## **St Tammany Parish comments on the *Pearl River Basin, Mississippi Section 211 Feasibility Study - Integrated Draft Feasibility and Environmental Impact Statement***

St. Tammany Parish is providing items that we believe should be included in the soon to be released document, *Pearl River Basin, Mississippi Section 211 Feasibility Study - Integrated Draft Feasibility and Environmental Impact Statement*. Recommendations are made on 1) technical inadequacies, 2) types of analyses that should be provided, 3) expanding the modeling domain/impact area and 4) necessary clarifications based on review of the public meeting notes and draft Feasibility & EIS Report (6/2018).

**Figure 2. Pearl River Reach near Proposed Alt. C Impoundment with Flow Characteristics**

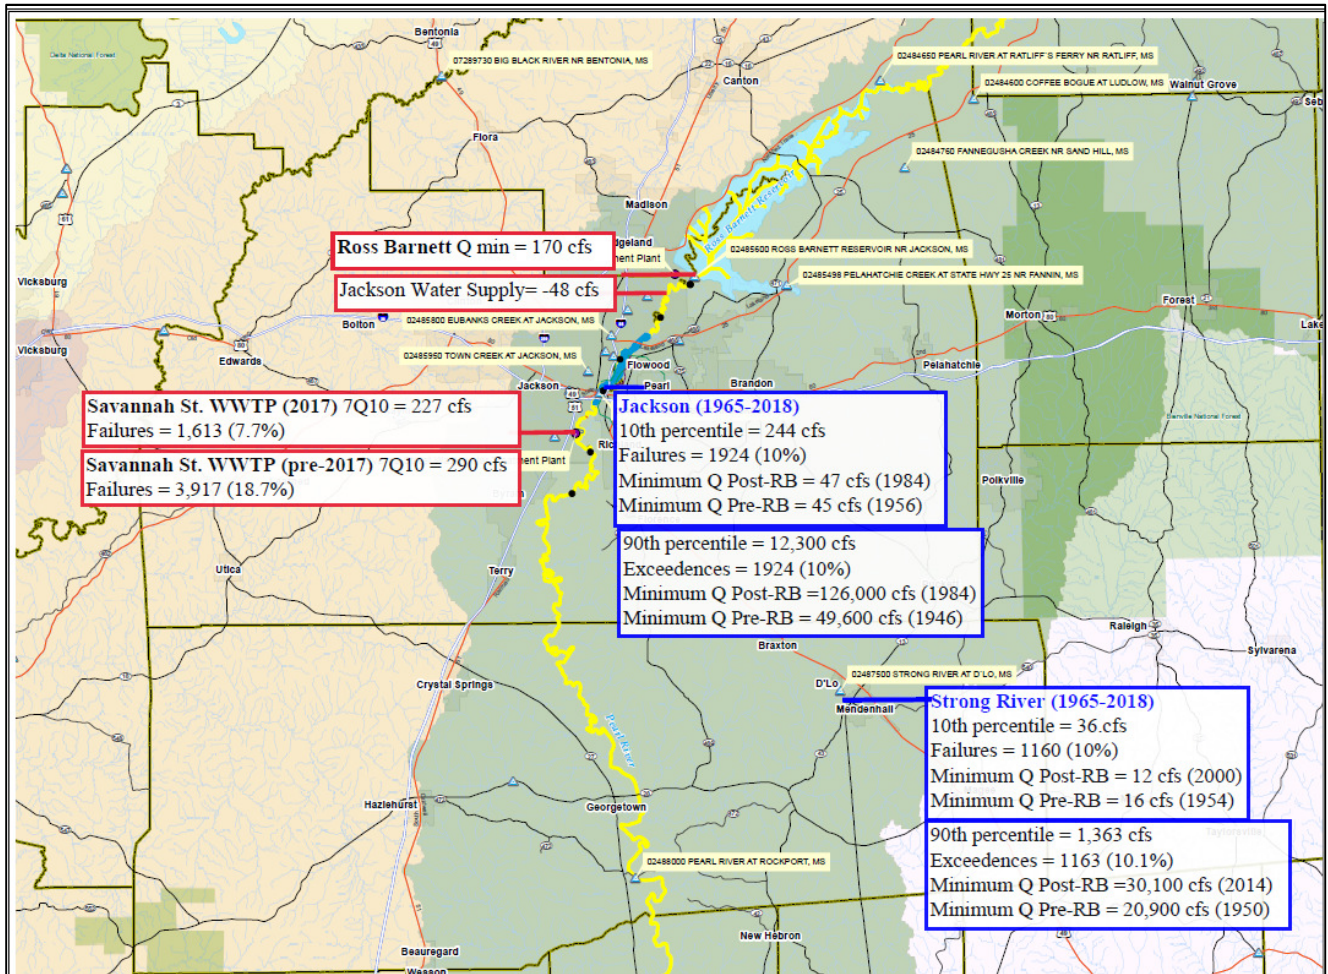
Construction of the Ross Barnett Reservoir (RB) began in 1960 and was completed in 1963. The 33,000 surface acre lake reached “full-pool” capacity in 1965<sup>1</sup>. Following construction of the Ross Barnett Reservoir near Jackson, MS. Minimum Mean Daily Discharges have remained approximately the same, from 45 cfs (10/5/1956) to 47 cfs (6/14/1984) for pre-RB versus post-RB, respectively (Figure 2).

**Figure 3. Mean Daily Discharge for USGS 02486000 (Pearl River at Jackson, MS) for the period of record**

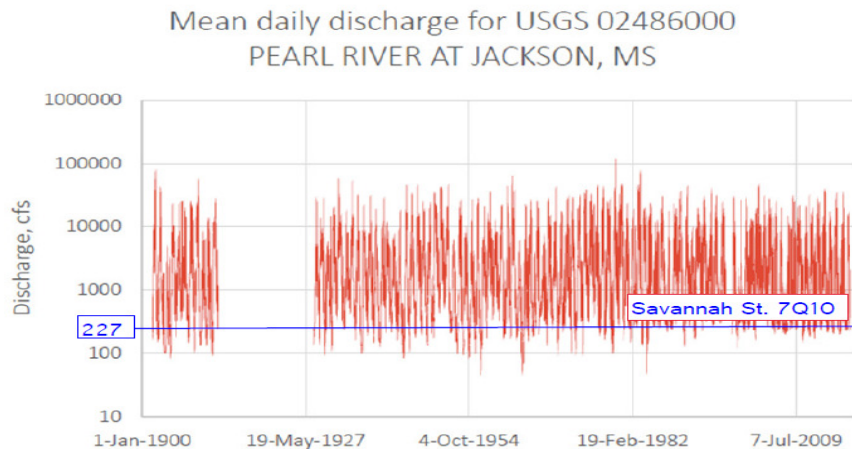
A 7Q10 of 227 cfs is the minimum stream baseflow measured on the USGS gage at Jackson required by MSDEQ for the most recent permit renewal (2017) for the 46 MGD City of Jackson Savannah St. WWTP discharge. Post-RB, there were 1,613 failures (7.7%) to meet this minimum flowrate (Figure 1). Mean Daily Discharge on the gage at Jackson show many measurements that are lower than the required 227 cfs for City of Jackson, Savannah St. Wastewater Treatment Plant (WWTP), as seen on the hydrograph in Figure 3.

The previous NPDES permit for the Savannah St. WWTP set the stream baseflow at 290 cfs for which there were 3,917 failures (18.7%). It seems counter intuitive that the permit should have been issued with a lower stream baseflow, with the River’s history of not attaining adequate flow. A TMDL for Nutrients<sup>2</sup> was implemented by EPA and MSDEQ in 2015 for the Pearl River from Ross Barnett to the Strong River. It seems plausible that inadequate stream baseflow at the Jackson gage during summer-critical conditions may be contributing to the lack of assimilative capacity at this location in the River incurring the TMDL.

**Figure 4. Pearl River Reach near Monticello, MS with Flow Characteristics**

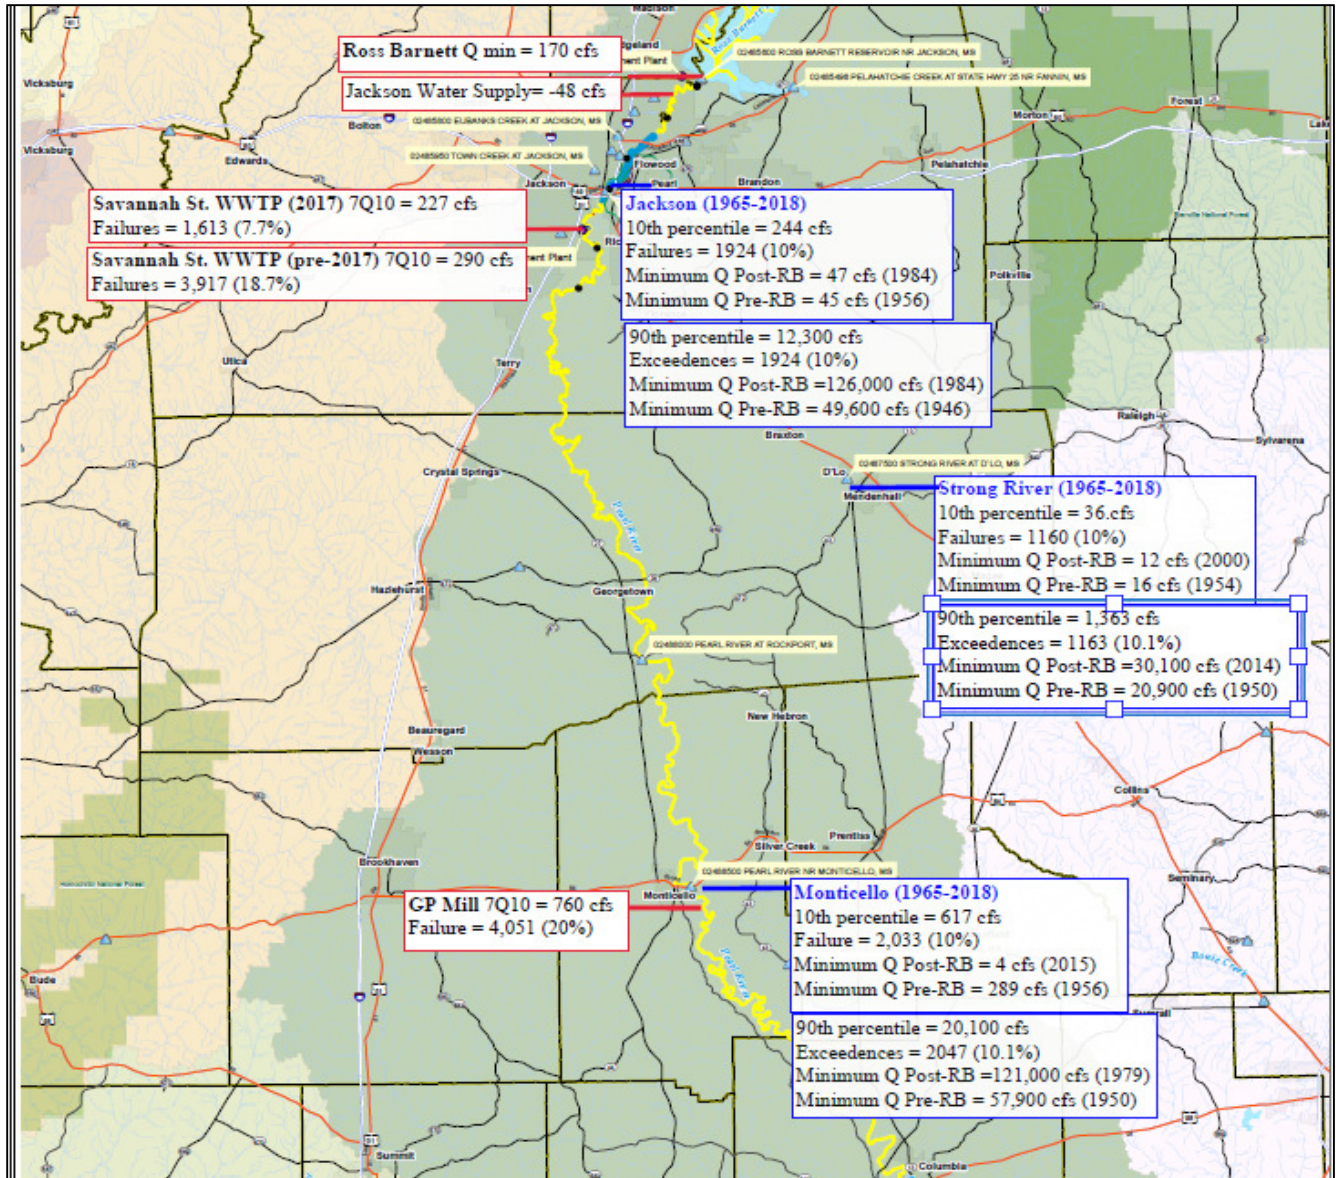
Monticello, MS is the location of a large NPDES discharger, Georgia Pacific (GP) Paper Mill (Figure 4). The 10<sup>th</sup> percentile flow post-RB is 512 cfs measured at the gage USGS 02488500 Pearl River at Monticello, MS, of which there were 854 measurements that failed to meet the 10<sup>th</sup> percentile (11%). The historic minimum flow at that location is 4.02 cfs. Residents along the River relay stories that the water was so low at that time that one could walk across to the other bank.

The 7Q10 for the 26.04 MGD (40.3 cfs) GP facility requires a stream baseflow of 760 cfs. There were 4,051 Daily Mean Discharge measurements (20%) that failed to meet that minimum. The Strong River, upstream of the Monticello gage, augments flow at this location (Figure 1); however, the post-RB 10<sup>th</sup> percentile for the Strong is 36 cfs measured at USGS 02487500 Strong River at D'Lo, MS. 1,160 Daily Mean Discharges failed to meet the 10<sup>th</sup> percentile (10%). The historic minimum was 12 cfs (8/31/2000).

- Clearly, stream baseflow, even with augmentation from the Strong River, is inadequate to meet the permit needs for this facility.

Figure 5. Pearl River Reach near Bogalusa, LA with Flow Characteristics

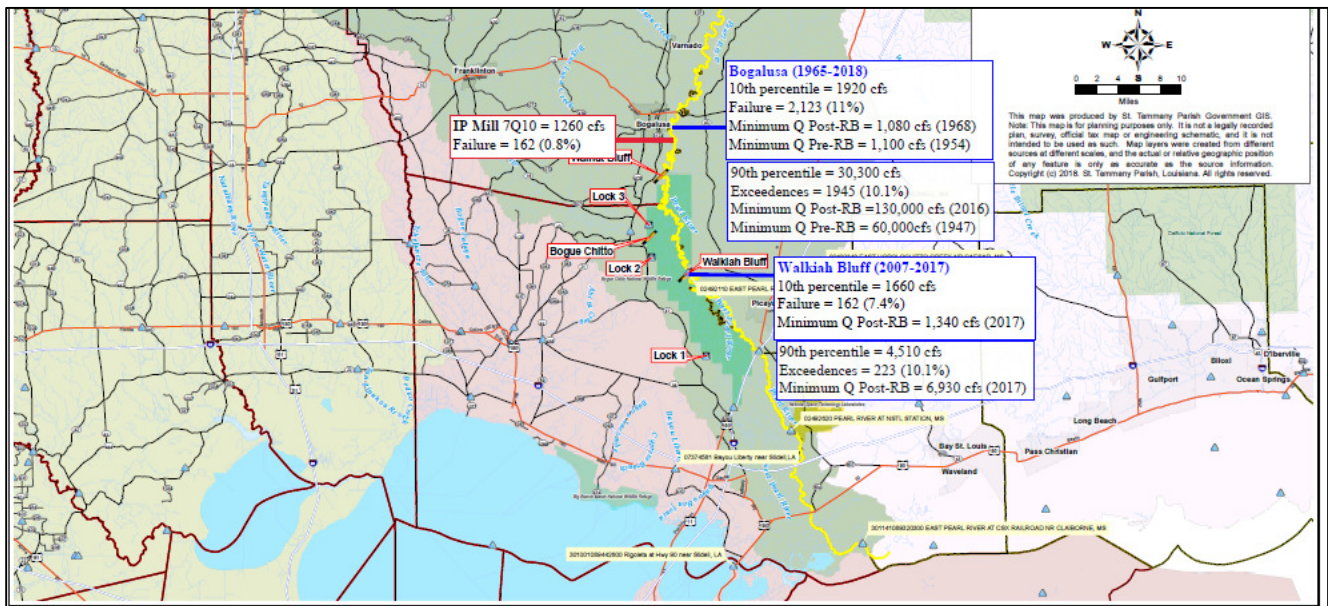
Bogalusa, LA is the location of a large NPDES discharger, International Paper (IP) Mill (Figure 5). The 10<sup>th</sup> percentile flow post-RB is 1,920 cfs, of which there were 2123 Daily Mean Discharges that failed to meet the 10<sup>th</sup> percentile (11%). The historic post-RB minimum flow at that location is 1,080 cfs. The 7Q10 for the 16 MGD (24.8 cfs) IP facility requires a stream baseflow of 1,260 cfs. There were 162 post-RB Daily Average Discharge measurements (0.8%) that failed to meet that minimum. While the minimum stream baseflow for this facility was well determined for the permit, there is little margin of safety in the stream baseflow, potentially incurring in-stream water quality violations during summer-critical conditions.

- There is a need for additional stream baseflow augmentation at this location in the Pearl River.

This site is of particular interest to oyster culture in coastal MS and LA (Figure 5). Adequate freshwater during summer critical conditions is necessary to mitigate the effects of saltwater intrusion and survivability of oysters in Lake Pontchartrain and the Mississippi Sound. Walkiah Bluff was constructed by the USACE to divert freshwater to the East Peal River during low-flow conditions. The 10<sup>th</sup> percentile Daily Mean Discharge measured at this gage is 1,660 cfs, of which 162 measurements <10<sup>th</sup> percentile (2007-2018). The historic minimum flow was 1,340 cfs (10/15/2007). A significant amount of debris is reportedly blocking the structure’s weir lessening the amount of fresh water being diverted.

- It is suggested that the USACE conduct maintenance on the Walkiah Bluff structure to restore its capacity.

Figure 6. Minimum Mean Daily Flows by Month minus proposed evaporative losses

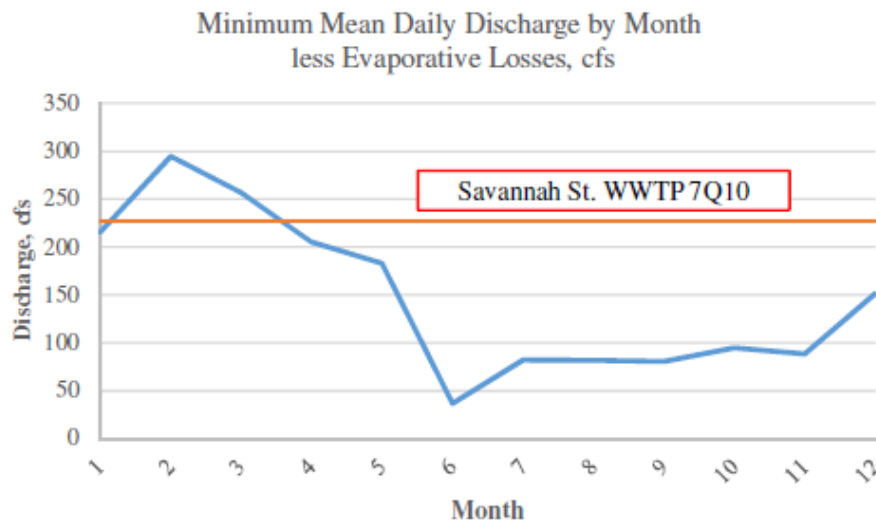
- Evaporative losses subtracted from either the Minimum Daily Mean Discharges by Month (Figure 6) or the 10<sup>th</sup> percentile of Mean Daily Discharges (Table 5) indicate the already-impacted Pearl River will be further compromised.

Figure 9. Predicted DO vs Observed DO at Sample Location downstream of the Ross Barnett gates

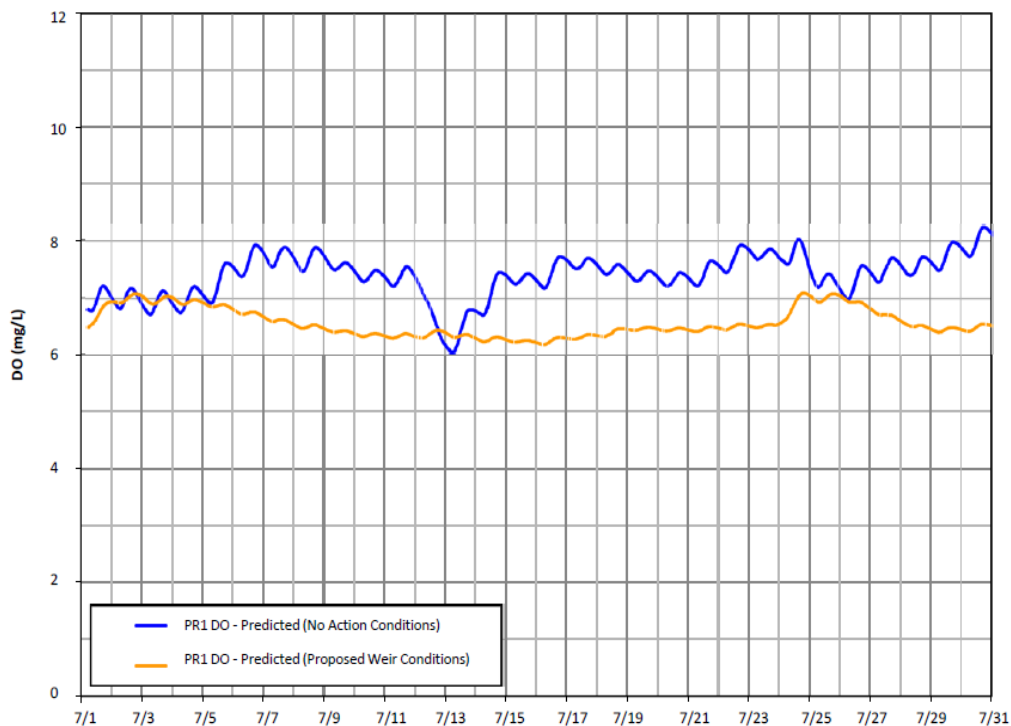
Using data from the July 2014 sampling event, the EIS team developed a model to predict the impact of the proposed impoundment. Figure 9 (EIS Appendix D, Water Quality, pg.119) presents model output of dissolved oxygen (DO) for two scenarios: 1) “No Action” (current conditions) and 2) Alternative C scenario. In the “No action” scenario, DO is significantly higher than the Alt. C scenario; however, EIS reviewers are assured that the DO in the Alt. C scenario will remain above the CWA criteria of 5.0 mg/L. Reviewers are asked to believe that the flow rates, pollutant concentrations, temperatures and decay coefficients used in the model are also correct. Assuming the 10<sup>th</sup> percentile flow rates were to be used, it is doubtful that the DO would maintain CWA DO minimums.

- St. Tammany Parish requests that a modeling scenario be conducted using “worse-case conditions” of 10<sup>th</sup> percentile flow rates and 32<sup>o</sup>C temperatures, with a minimum 20% increased loadings to represent a margin of safety for growth.

Further, DO appears to FAIL EPA anti-degradation criteria for dissolved oxygen (< 0.2 mg/L) with Alt. C impoundment. LDEQ’s water quality standards define degradation as “a lowering of water quality, as demonstrated by data analysis, water quality models, or other scientifically defensible method.” So, a lowering of the dissolved oxygen content, as predicted by a model, is considered degradation. Per LAC 33: IX, Chapter 15 (Water Quality Certification Procedures), LDEQ has the responsibility to certify that federal permits or licenses will not violate water quality standards, so the application of the antidegradation policy is not limited to industrial discharges.

**Figure 10. Locations of Coastal Restoration Projects and CRMS sites in the Pearl River vicinity**

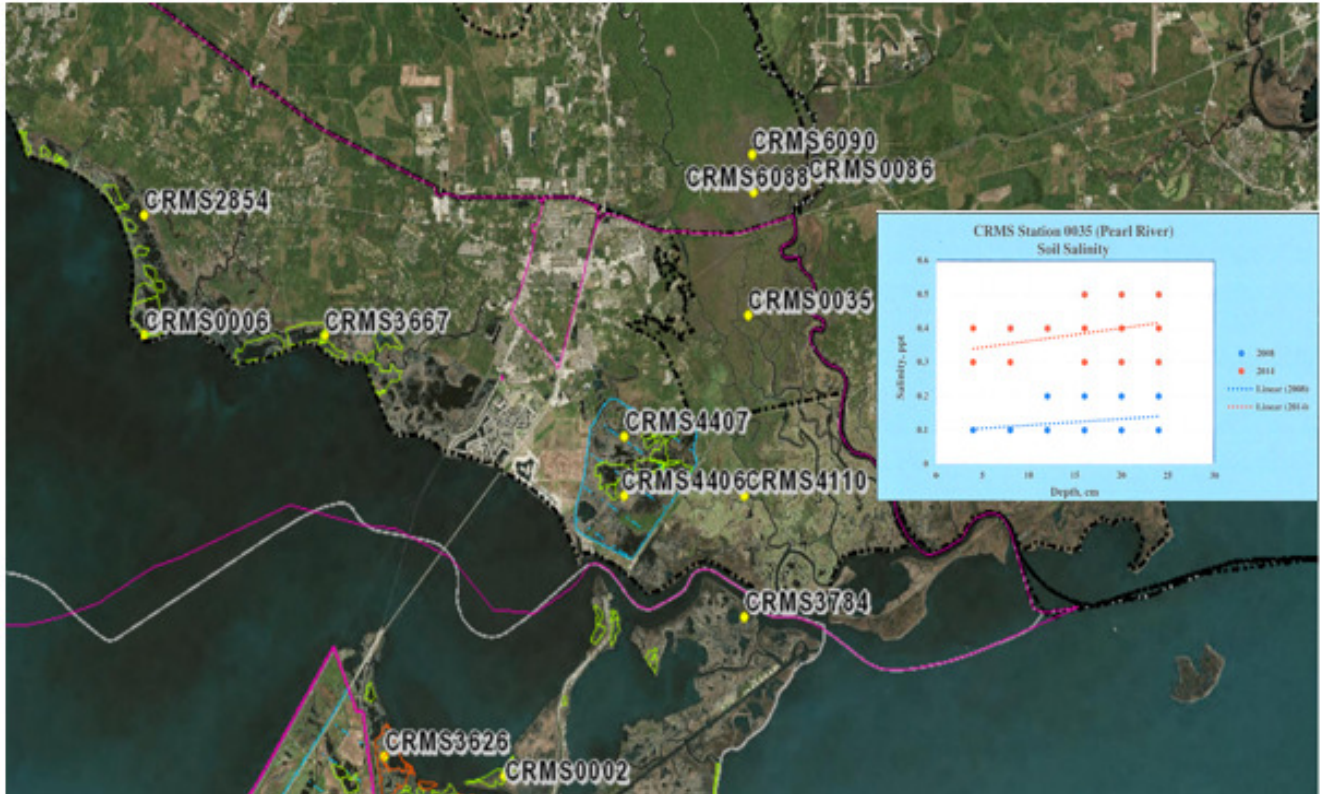
Since 2006, the Louisiana Coastal Protection and Restoration Authority (CPRA) and the US Geological Survey (USGS) have developed and maintained a Coastwide Reference Monitoring System (CRMS) for wetland restoration efforts. There are three CRMS sites in the vicinity of coastal Pearl River and a number of coastal restoration projects that are in the construction or engineering/development phase (Figure 10). These projects are vital to the restoration and resiliency of the Louisiana coastline and provide surge protection to inland communities.

The CRMS site houses monitoring datasets of hydrogeomorphological parameters that characterize coastal habitats in Louisiana. Some of the parameters that are monitored include water level, soil porewater salinity, percent organic content and surface elevation/accretion. The CRMS site link is: <http://www.lacoast.gov/crms2/Home.aspx>. All CRMS indicate increased saline concentration in porewater, perhaps attributable to less fresh water flowing down the Pearl River in low flow months.

- St. Tammany Parish recommends that monitoring at the CRMS sites continue, particularly to monitor for salt water intrusion.
